January 21, 2024

Comments on Eversource’s Hurd State Park project:

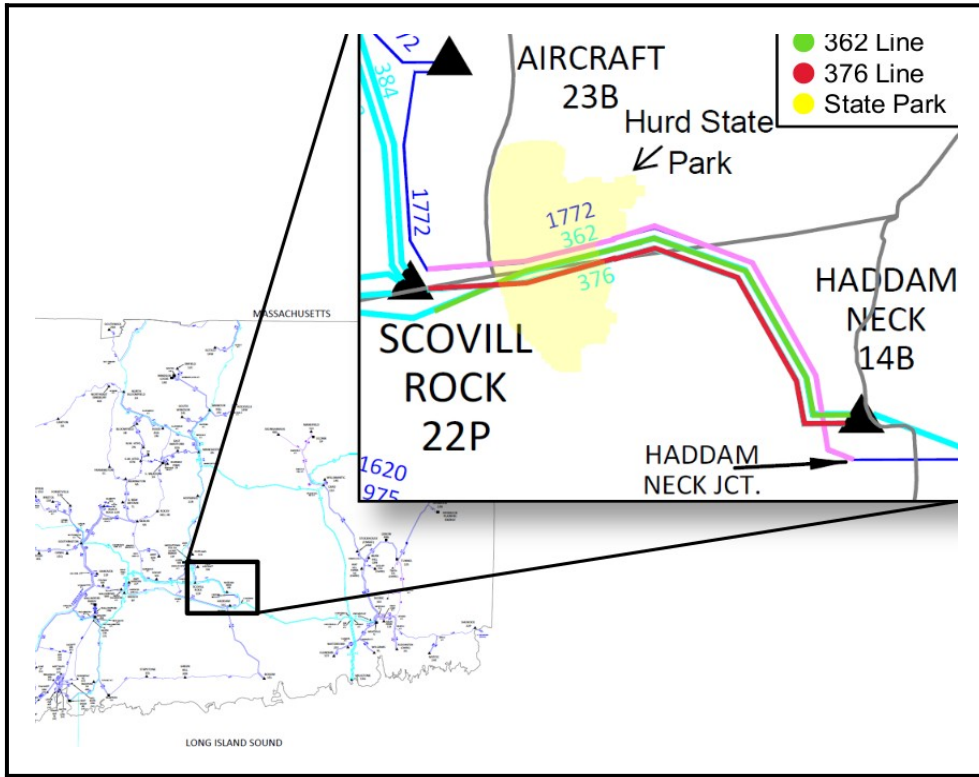
Page 4: The map of the project location reduces a real place to a set of lines. This project goes through a State Park and crosses the Connecticut River and deserves a map that shows this, as well as photographs of the existing structures and simulations of the proposed structures. Eversource’s “map” fails to show that the yellow area south of the proposed powerlines project is George Dudley Seymour State Park.

Do the transmission easements pre-date the creation of the State Park?

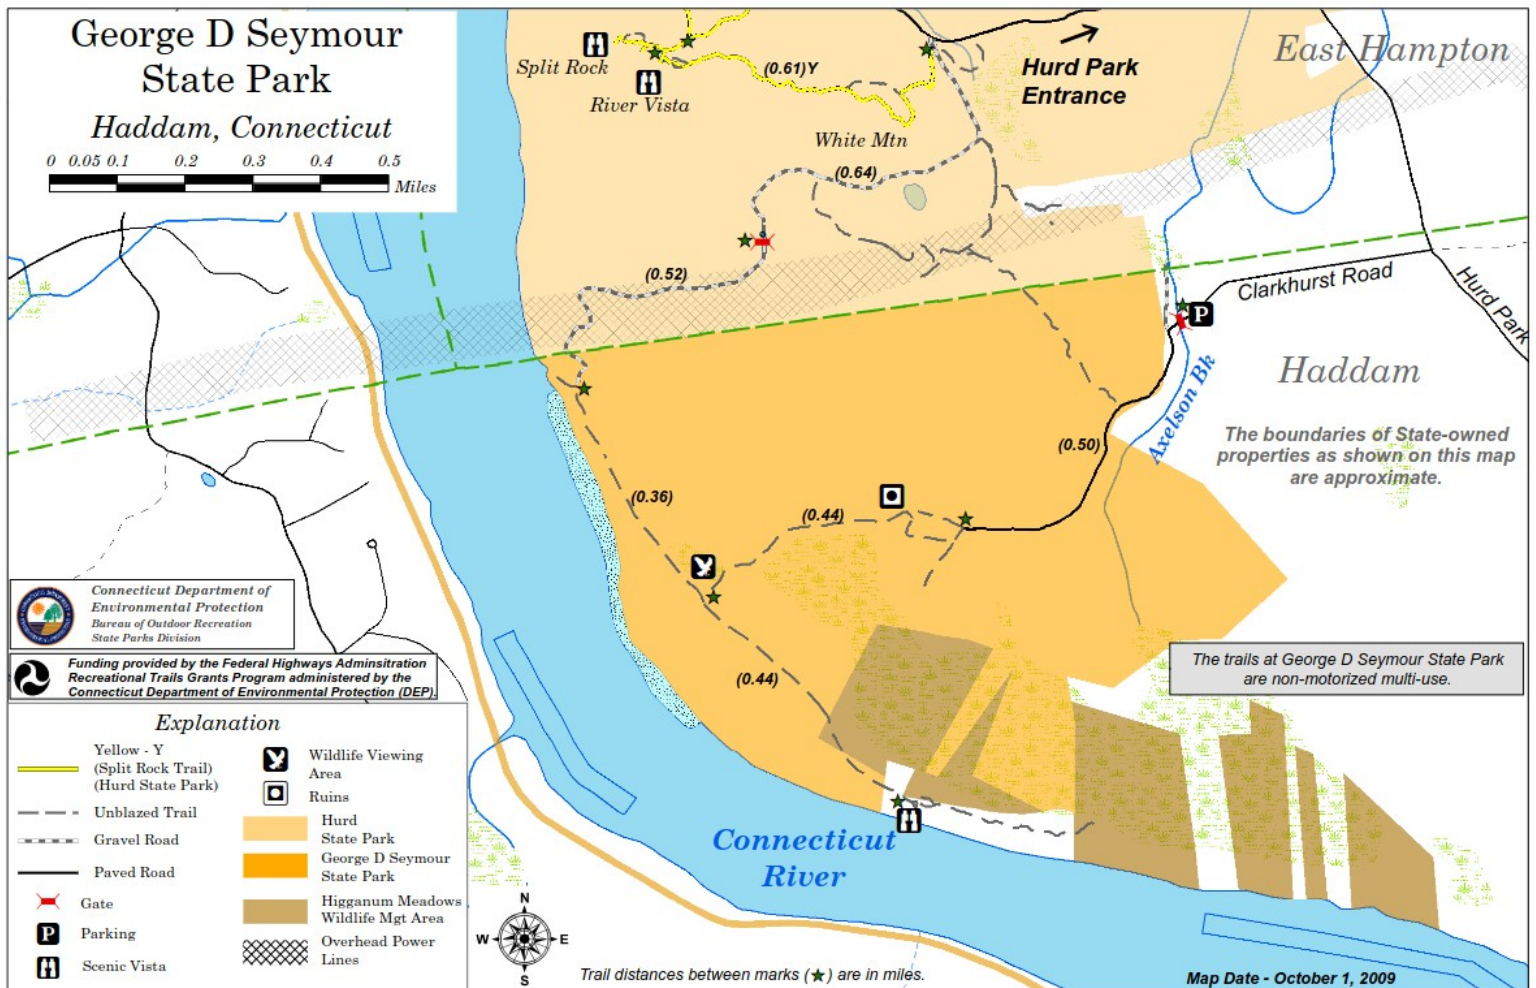
Eversource should have provided, and needs to provide now, a map like the one below but with the addition of topo lines and the proposed locations of the structures Eversource plans to replace. This should have been posted months ago, at both Park entrances, to reach the real stakeholders.
